UNITED'STATES NUCLEAR REGULATORY COMMISSION WASHINGTON, D. C. 20555

Docket No. 50-409

RE: LACROSSE

Thomas S. Moore, Esq. Atomic Safety and Licensing Appeal Board U. S. Nuclear Regulatory Commission Washington, D. C. 20555 ATTACHMENT 1

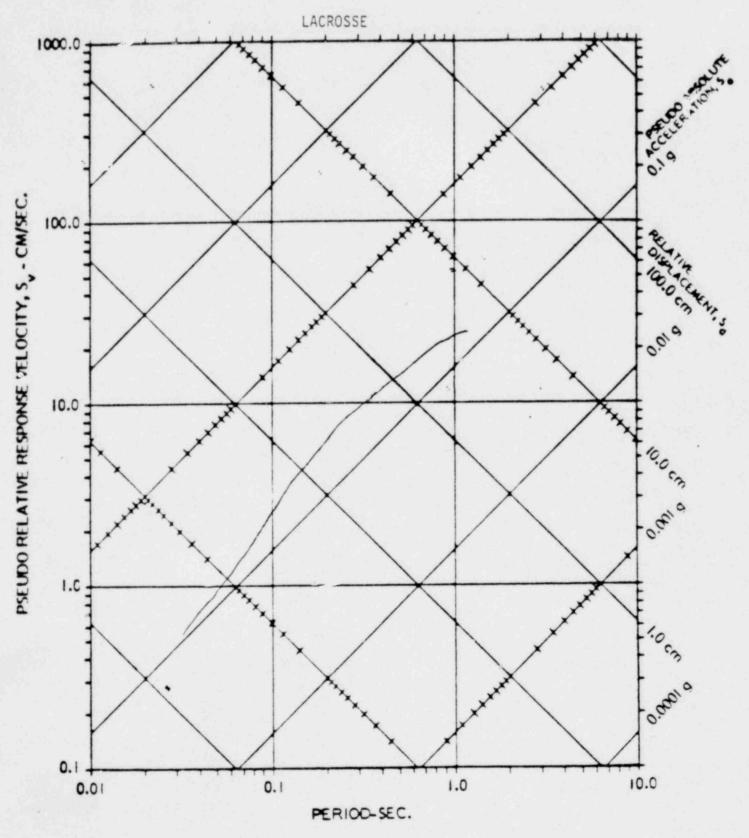
in Attachment 1 will be modified to a large degree. Therefore, we strongly recommend that you use this ground response spectrum in your evaluations. The bases for our decision are documented in Attachment 2.
